UNITED STATES PATENT AND TRADEMARK OFFICE

10/612,913

Office Action Summary

DETAILED ACTION

Shimizu discloses in Figure 19A and respective portions of the specification a non-volatile semiconductor memory device as claimed.

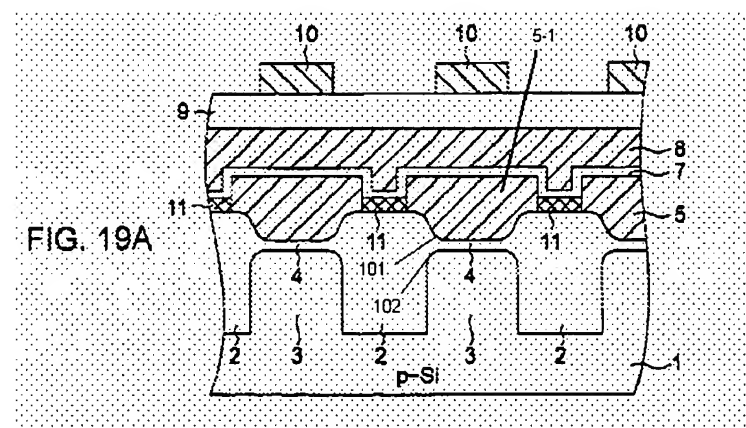
Referring to **claim 1**, Shimizu discloses a non-volatile semiconductor memory device comprising:

a semiconductor substrate (1) having a main surface provided with two spaced trenches (defined generally by isolation insulators 2);

an isolation insulator (2) filling said trench, said isolation insulator having an upper surface with an end having a curvature (101, as marked by the examiner) protruding toward said semiconductor substrate;

a floating electrode (5-1, as marked by the examiner) having a flat surface and extending from the main surface of said semiconductor substrate between said two trenches to said two isolation insulators;

an insulation film (7) extending from the upper surface of said floating electrode to a side surface of said floating electrode overlying said isolation insulator; and

a control gate (8) disposed on said insulation film to extend from the upper surface of said floating electrode to the side surface of said floating electrode.

Referring to **claim 2**, Shimizu further discloses that a sidewall surface of said trench and the main surface of said semiconductor substrate underling said floating electrode are connected together by a portion (102, as marked by the examiner) providing said semiconductor substrate with a curved surface.
